**County of San Diego
Planning & Development Services
BUILDING DIVISION**

ACCESSIBILITY CORRECTION LIST Public Accommodations & Commercial Buildings	1B
Site Accessibility and Exterior Routes of Travel

**FIGURE 11B-302.3
ELONGATED OPENINGS IN FLOOR OR GROUND SURFACES**

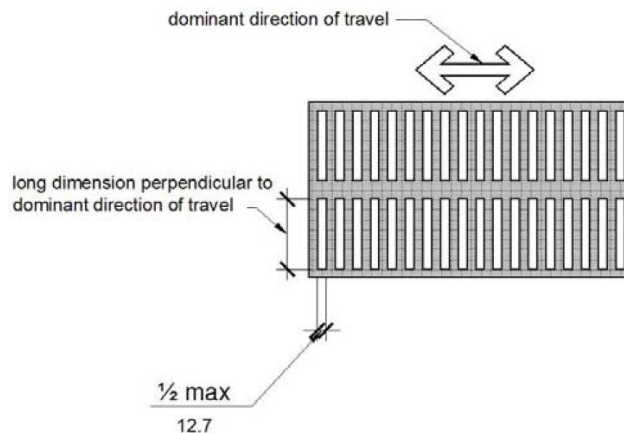
14. For abrupt changes in level greater than 1/2 inch on accessible routes, provide pedestrian ramp per accessibility correction list 4B.
Exception: Changes in level served by curb ramps shall meet requirements of accessibility correction list 3B CBC 11B-303.4
15. Identify on site accessibility plan any grates or similar openings located on accessible routes and detail maximum 1/2-inch spaces per CBC Figure 11B-302.3 with any elongated openings placed perpendicular to dominant direction of travel.

FIGURE 11B-705.1
SIZE AND SPACING OF TRUNCATED DOMES

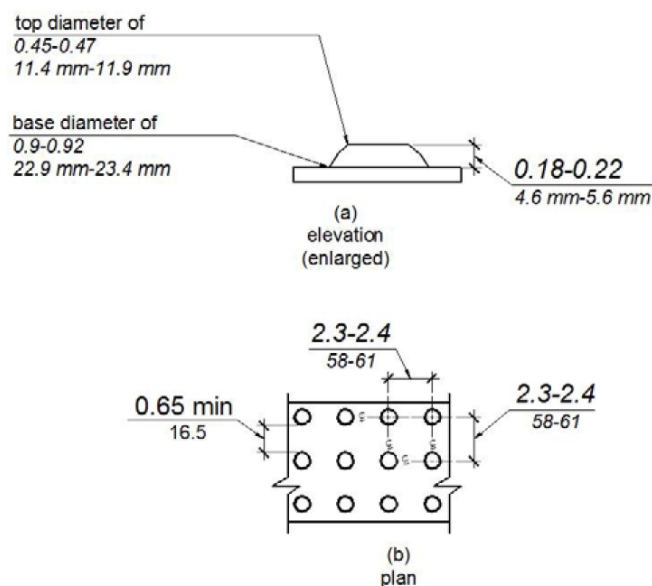
22. Detectable warnings required per items 19, 20, or 21 shall comply with the following:
- ❑ Including raised, truncated domes per CBC Figure 11B-705.1:

- Minimum 0.9-inch and maximum 0.92-inch base diameter
 - Minimum 0.45-inch and maximum 0.47-inch top diameter
 - Minimum 0.18-inch and maximum 0.22-inch height

- Minimum 2.3-inch and maximum 2.4-inch center-to-center spacing and minimum 0.65-inch base-to-base spacing**Exception:** Minimum 1.6-inch and maximum 2.4-inch center-to-center spacing acceptable for domes in radial pattern

FIGURE 11B-307.4
VERTICAL CLEARANCE

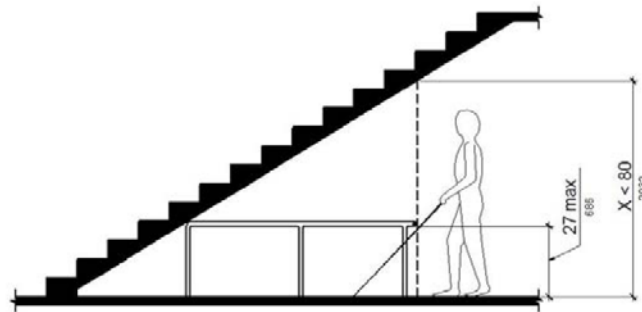
24. Where circulation paths adjoin areas with less than 80-inch vertical clearance – e.g., open areas beneath stairs – detail cane-detectable barrier at maximum 27 inches above walking surface per CBC Figure 11B-307.4.

FIGURE 11B-307.2
LIMITS OF PROTRUDING OBJECTS

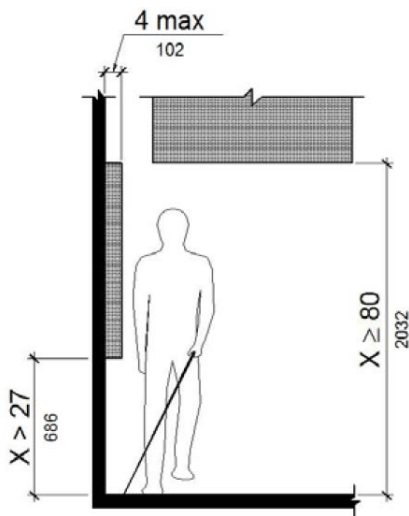
25. Identify on site accessibility plan any objects protruding into circulation paths and dimension to comply with the following:
- 4-inch maximum horizontal protrusion of any wall-mounted object with leading edge between 27 inches and 80 inches above walking surface per CBC Figure 11B-307.2
Exception: Maximum 4-1/2 inches for handrails
Exception: Door closers and door stops may be minimum 78 inches above walking surface

FIGURE 11B-307.3
POST-MOUNTED PROTRUDING OBJECTS
CBC 11B-204.1, CBC 11B-307.2, CBC 11B-307.3, and CBC 11B-307.4

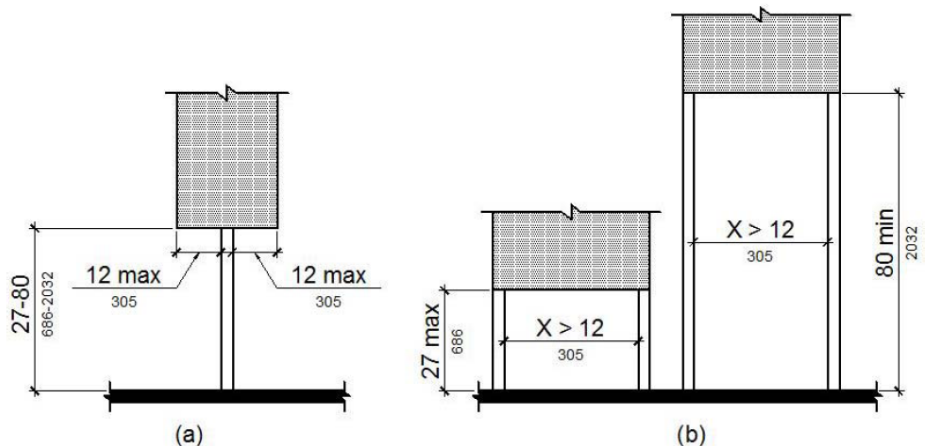
- 12-inch maximum overhang of any post-mounted object with leading edge between 27 inches and 80 inches above walking surface per CBC Figure 11B-307.3(a)

- Lowest edge of sign or other object maximum 27 inches or minimum 80 inches above walking surface where mounted between posts spaced greater than 12 inches apart per CBC Figure 11B-307.3(b)
